V2500-A5 SERIES PROPULSION SYSTEM SERVICE BULLETIN

This document transmits Revision 1 to Service Bulletin EV2500-72-0267

V2500-ENG-72-0267

ENGINE – HP TURBINE ROTOR AND STATOR ASSEMBLY – INTRODUCE NEW SECOND STAGE TURBINE
BLADES WITH MORE DURABLE TIPS AND IMPROVED REPAIRABILITY

Location of the Stage 2 HPT Blade Assembly
Figure 1

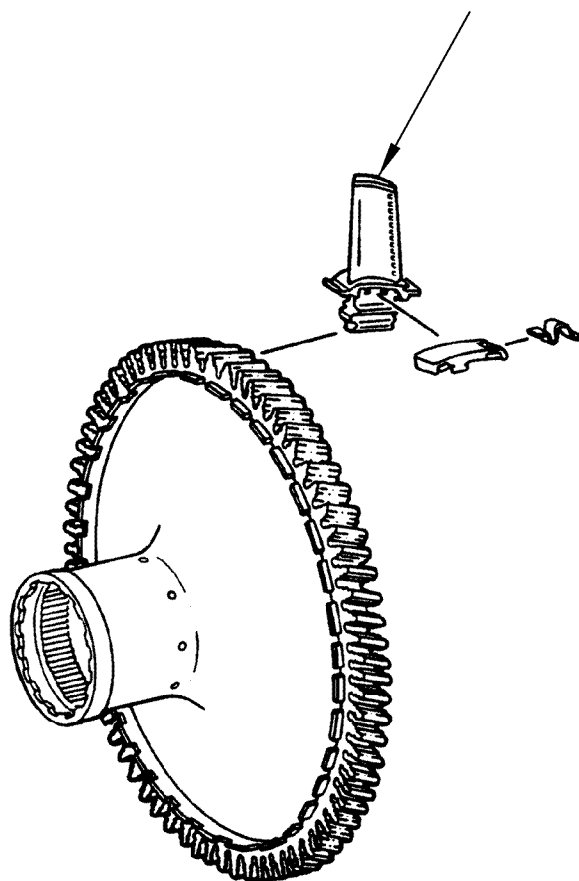
- (1) Replace the Stage 2 HPT Blades (72 off) by the approved procedure given in Reference (2), Chapter/Section 72-45-30, Assembly-01 and Figure 1.
- (2) Recording Instructions
 - (a) A record of accomplishment is required.

REPLACE THE STAGE 2 HPT
BLADE ASSEMBLY
PN 2A2702 WITH PN 2A8702
